Application for Works Approval Amendment

Works Approval Number	W6908/2024/1
Works Approval Holder	Roo Brew Pty Ltd
ACN	654 500 017
File Number	DER2024/000055
Premises	Lucky Bay Brewing 66 Bandy Creek Road BANDY CREEK WA 6450 Legal description – Lot 66 on Plan 415322 and part of Lot 4 on Plan 61342 as defined by the coordinates and premises map in Schedule 1 of the Revised Works Approval.
Date of Report	11/02/2026
Decision	Revised works approval granted

This amendment report documents the assessment of potential risks to the environment and public health from proposed changes to the emissions and discharges from the amended wastewater treatment plant system design, addition of geobags and an increase to the wastewater disposal (irrigation) area. As a result of this assessment, revised works approval W6908/2024/1 has been granted.

Figure 1: Proposed wastewater treatment plant layout and flow pathway

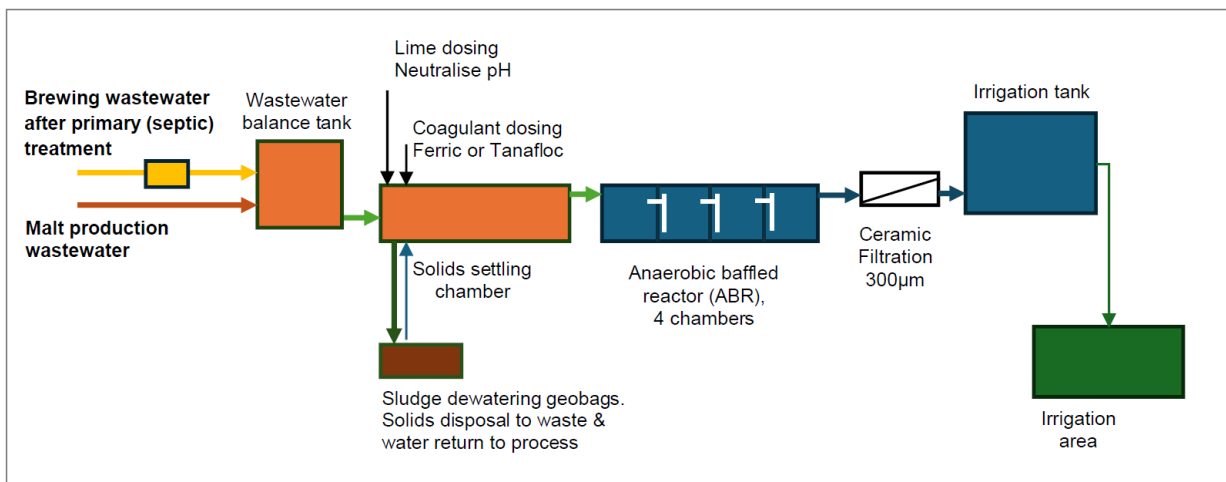
The works approval holder has amended the design of the proposed WWTP from an aerobic to an anaerobic system (see Figure 1) as the treatment process will require long periods (1 to 12 weeks) without wastewater inflow due to irrigation restrictions during winter (existing conditions of the works approval). They have stated that high biological oxygen demand

Brewery wastewater (after primary (septic) treatment) and malt production wastewater will be combined in a wastewater balance tank prior to being directed to a below-ground solids settling chamber. The balance tank will be used to manage wastewater inputs of up to 18.25 kL/day.

Lime dosing will occur at the inlet to the solids settling chamber for pH correction. A non-aluminium coagulant will be added to the solids settling chamber to increase the settling of suspended solids, removing contaminants.

The wastewater will then be directed to an anaerobic baffled reactor which will consist of four modified below-ground septic chambers in sequence. The critical modification will be to extend the inlet pipe tee to the base of the tank to promote wastewater flow through the anaerobic sludge 'blanket'.

Finally, the wastewater will pass through a ceramic membrane filter to further remove nitrogen and phosphorus prior to the wastewater being directed to the wastewater irrigation holding tanks.

The anaerobic process will target methanogenesis for BOD and chemical oxygen demand (COD) digestion with the preferable temperature range being 25°C to 40°C. Due to the colder, winter ambient air temperatures in Esperance, the design of the WWTP intends to capture the hot wastewater and retain the heat in an above-ground black polyethylene wastewater balance tank and the underground treatment tanks.

Operation						
Management of alcohol and malt manufacturing wastewater – below-ground anaerobic WWTP system. <i>Previously assessed as an above-ground aerobic WWTP system.</i>	Odour from wastewater processing	Air / windborne pathway causing impacts to health and amenity. Residences 350 m SW, 530 m NNW and 950 m W of proposed WWTP.	<ul style="list-style-type: none"> Settling tank and anaerobic baffled reactor (4 tanks) will be located below-ground and are enclosed. Settling tank and anaerobic baffled reactor tanks will be modified septic tanks and will be manufactured to Australian Standard AS/NZS 1546.1. Desludging pump to pump sludge from the settling tank to the geobags. 	C = Slight L = Possible Low Risk	With the nature of wastewater, there is an inherent risk of odour causing impacts to offsite receptors, particularly from wastewater stored in tanks for a period. The delegated officer has considered the distance to receptors, and the design of the proposed WWTP (mostly below-ground) and has determined the risk to be low. Works approval holder controls will be conditioned to ensure the risk event remains low. Wastewater from the brewery and malt facilities drains to the wastewater balance tank before being transferred to a settling tank followed by four anaerobic baffled reactor tanks. The wastewater then passes through a ceramic filter before being transferred to the irrigation holding tanks. The delegated officer has considered the design of the proposed WWTP, distance to receptors and works approval holder proposed controls and has determined the risk to be medium. Relevant existing conditions will remain on the works approval, with some conditions amended to reflect works approval holder controls for the proposed change to the WWTP design (below ground anaerobic system rather than an above ground aerobic system) to ensure the risk is minimised.	Existing conditions Conditions 8 – 9: Time limited operational phase – commencement and duration Condition 10: Operational requirements Works approval holder controls conditioned Condition 10: Operational requirements

Leaks of wastewater contaminants with nutrient laden wastewater from underground tanks and pipework. Leaks and overtopping from above-ground tanks.	Seepage of untreated and treated wastewater to soil and groundwater. Groundwater 2 – 4 mbgl. Bandy Creek is approximately 600 m SW of proposed WWTP.	<ul style="list-style-type: none"> Anaerobic baffled reactor (four tanks) will be placed in series, at increasing depth to allow for wastewater flow. The inlet pipe tee for each tank will be modified to extend to the base of each anaerobic baffled reactor tank to promote wastewater flow through the anaerobic sludge. September 2025 groundwater monitoring data showed the groundwater level at 4.1 and 4.2 mbgl, after a wet winter. Groundwater will not rise to the depth of the underground WWTP tanks. Flows entering the system and flows discharged to irrigation will be monitored to detect any leaks in the WWTP infrastructure. Wet-well submersible pump to direct wastewater from tank 4 of the anaerobic baffled reactor to the ceramic membrane filter. Ceramic membrane filter and any future wastewater recovery equipment will be housed in a bunded area with any spills or backflush to be returned to the settling tank. Above-ground wastewater balance tank has a visual level gauge to monitor available wastewater storage volumes; and will be visually monitored. 	C = Minor L = Unlikely Medium Risk

Existing conditions in the works approval relating to the previous above-ground aerobic WWTP system have been removed, with design/installation requirements and works approval holder controls for the below-ground anaerobic WWTP system and proposed geobags being included on the works approval (see sections 4 and 6.1).
